# Access Compliance Report

## Public Rights-of-Way

### (Pedestrian Signals)

Intersection ID: N/A	Main Street:	Cross Street: N/A	Location: N/A
ADA ID: 4F8EE1BC570E	Signal Type: One Push Button-Non APS	Overall Compliance: No	Severity Score: BTN 1: N/A BTN 2: N/A No BTN: N/A
Codes/Mitigation Info/Possible Solution		Field Measurements/Component Compliance

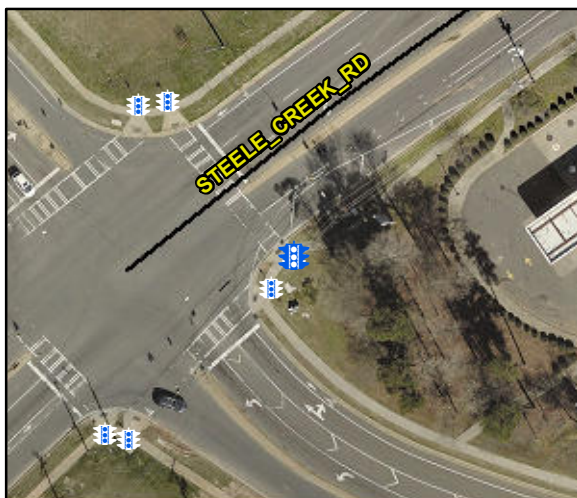
PROW/ADA: TMUTCD 4e.08, R404.2, R404.3, R406.2

Yes	B 1 Clear Xing Direction?	ClearlyMarked	N/A	B 2 Clear Xing Direction?	N/A
	B 1 Crossing Direction	To NW		B 2 Crossing Direction	N/A
Yes	B 1 DistanceTo XWalk (in)	0.0	N/A	B 2 DistanceTo XWalk (in)	N/A
No	B 1 DistanceTo Curb (in)	118.0	N/A	B 2 DistanceTo Curb (in)	N/A
Yes	B 1 Diameter (in)	2.0	N/A	B 2 Diameter (in)	N/A

Possible Solutions: Replace Signal Push Button With APS Button on New Post. Remove & Relocate Sign.
